City of Chattanooga

Citywide Right-Of-Way Concrete Contract T-18-008-201 - **Addendum #2**

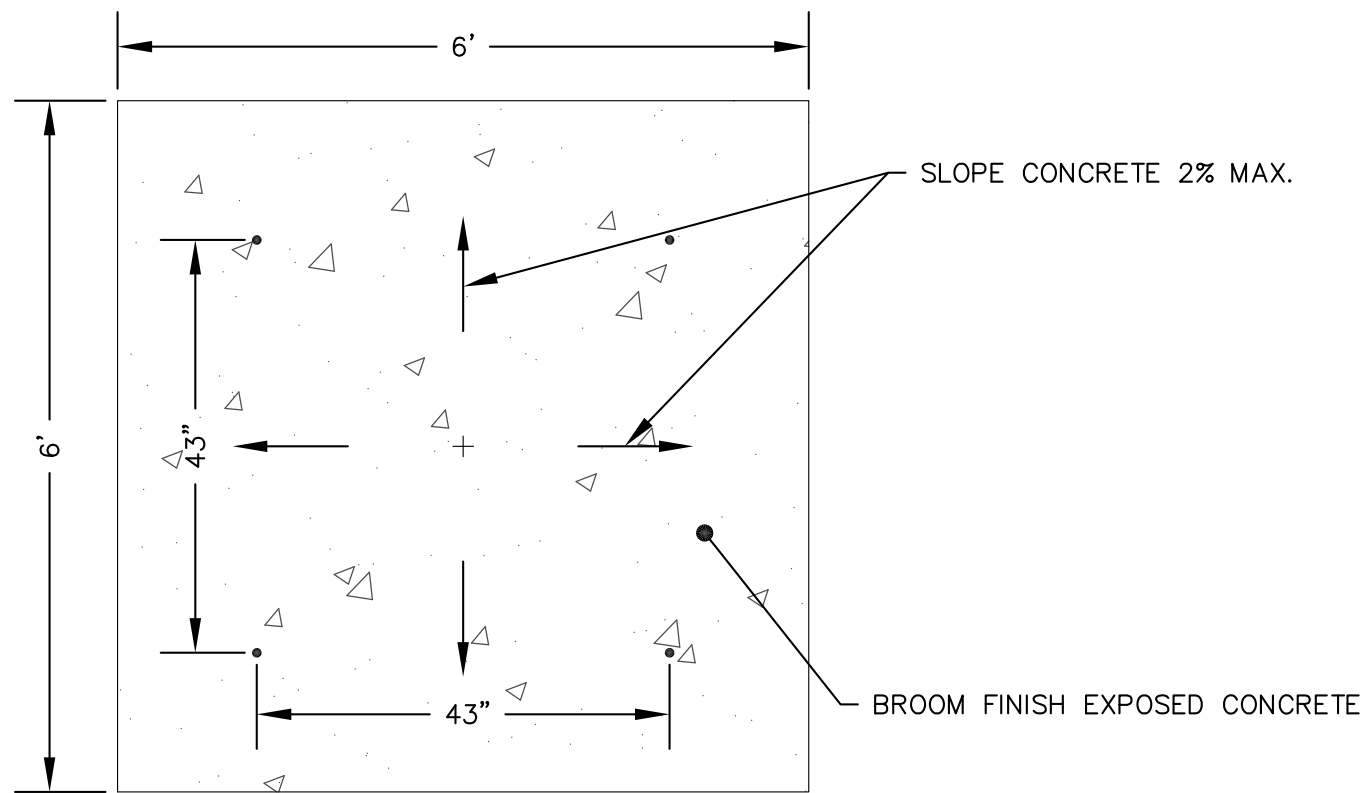
1) *Misc – F Segmental Retaining Wall. => The description calls for modular units... Is this considered a stacked “Redi Rock” wall? Or is this a CMU retaining wall?*

– Neither. This refers to a 16” x 6” Basic Retaining Wall Block, similar the attached image and specifications.

STAIRS TYPICAL SECTION

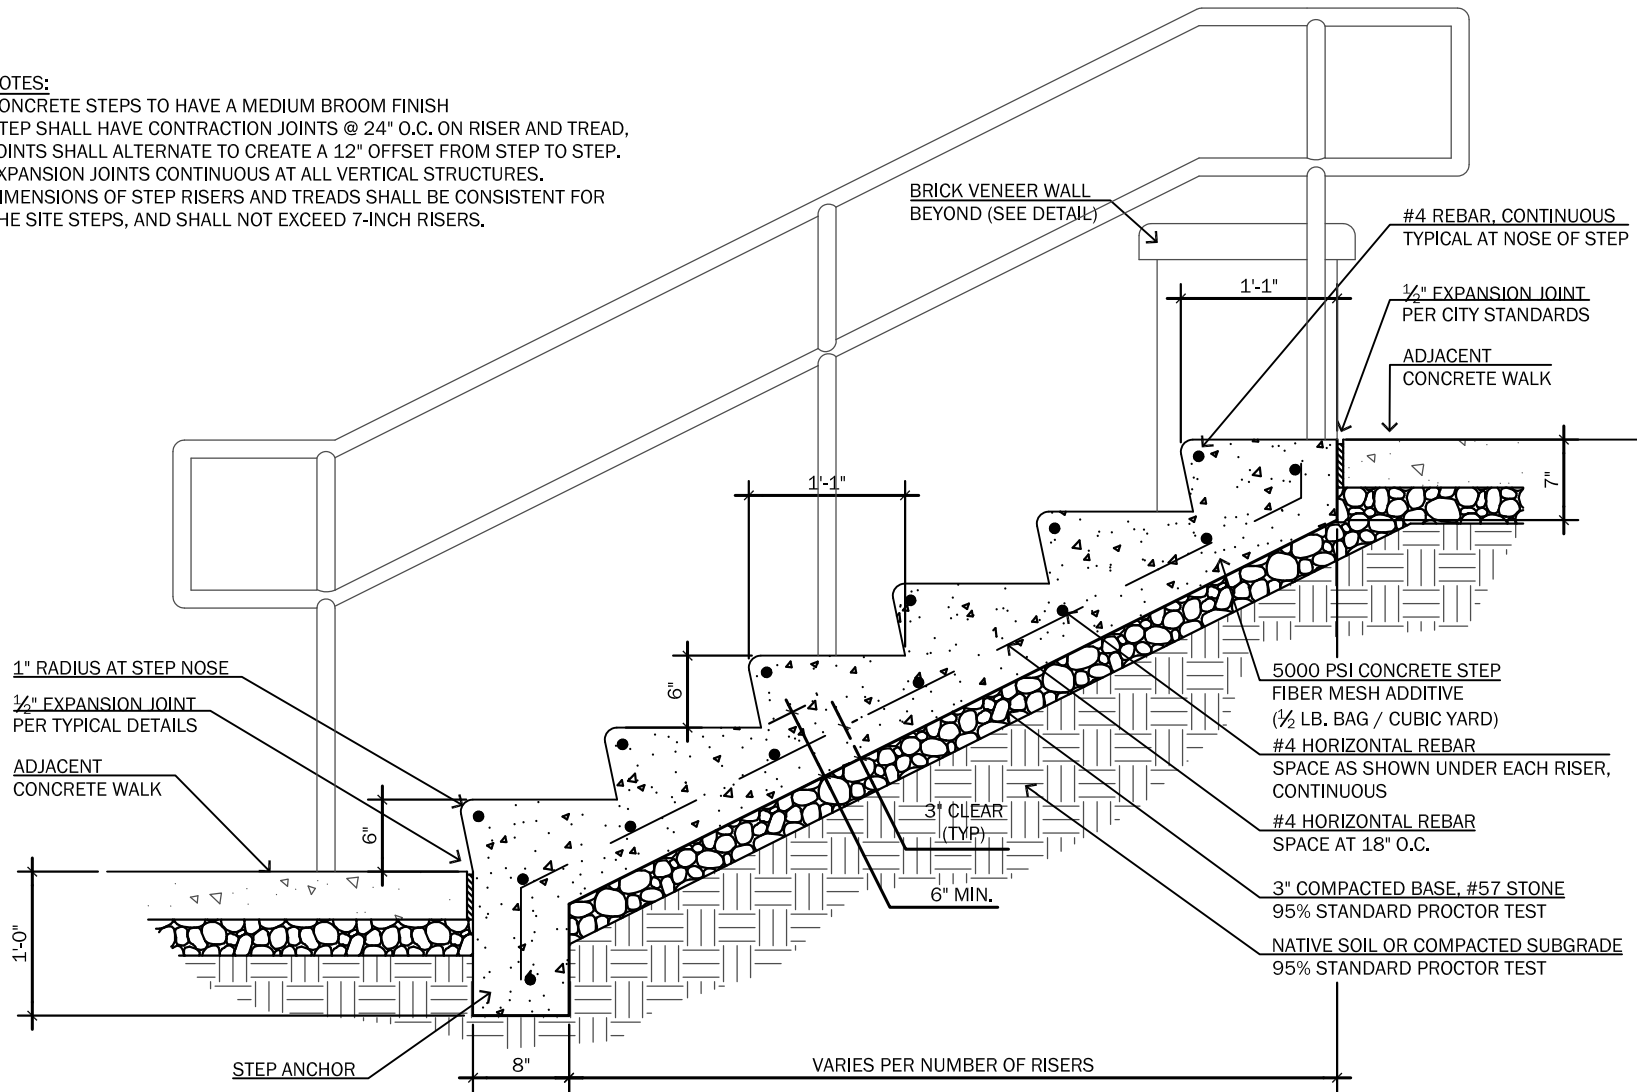
3) *Typical Handrail Section & Typical Stairs Section contradict which type of handrail to use. Typical Stair Sections calls for a “Nominal 1.5” Galvanized Steel Handrail”. Typical Handrail calls for “2” Dia. Tube Steel primered and painted black. Which handrail is going to be used?*

– The discrepancies have been revised on the attached revised Appendix C. Typical handrail will be a double rail 1.5” diameter tube steel primed and painted either RAL9005 (Jet Black) or RAL6005 (Moss Green).
